Re: Response to Deficiencies Task ID #4372 (Revision for pond cleaning (13-007))

<input type="checkbox"/> Permit Change	<input type="checkbox"/> New Permit	<input type="checkbox"/> Renewal	<input type="checkbox"/> Transfer	<input type="checkbox"/> Exploration	<input type="checkbox"/> Bond Release	Permit Number: 015/032
Title of Proposal: Crandall Sediment Pond Revisions (13-007)						Mine: GENWAL Mine
						Permittee: GENWAL Resources, Inc.

APPENDIX 7-4

*CRANDALL CANYON MINE
SEDIMENTATION AND DRAINAGE CONTROL PLAN*

**CRANDALL CANYON MINE
SEDIMENT POND (AS-BUILT)**

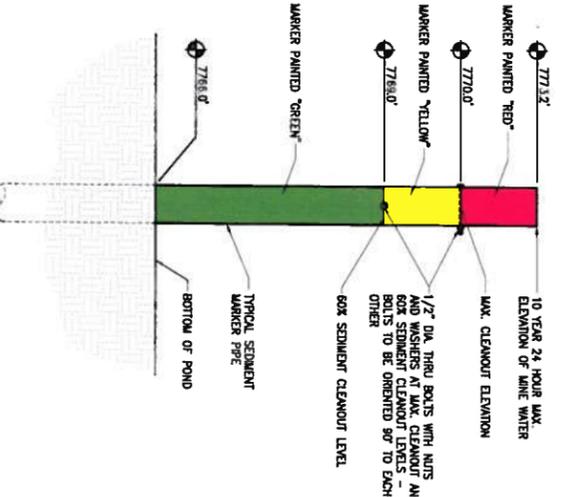
Pond Cleaned in June 2013.

±300 tons of bentonite was added to augment the existing clay liner (June 2013).

LOCATION	ELEVATION	VOLUME	VOLUME AFTER 2013 CLEANING
BOTTOM OF POND:	7786.00	0.000 AC. FT.	0.000 AC. FT.
SEDIMENT CLEANOUT LEVEL:	7789.00	0.290 AC. FT.	0.330 AC. FT.
MAXIMUM SEDIMENT LEVEL:	7770.00	0.437 AC. FT.	0.481 AC. FT.
PRINCIPAL SPILLWAY:	7780.81	3.513 AC. FT.	3.915 AC. FT.
EMERGENCY SPILLWAY:	7781.81	3.936 AC. FT.	4.391 AC. FT.
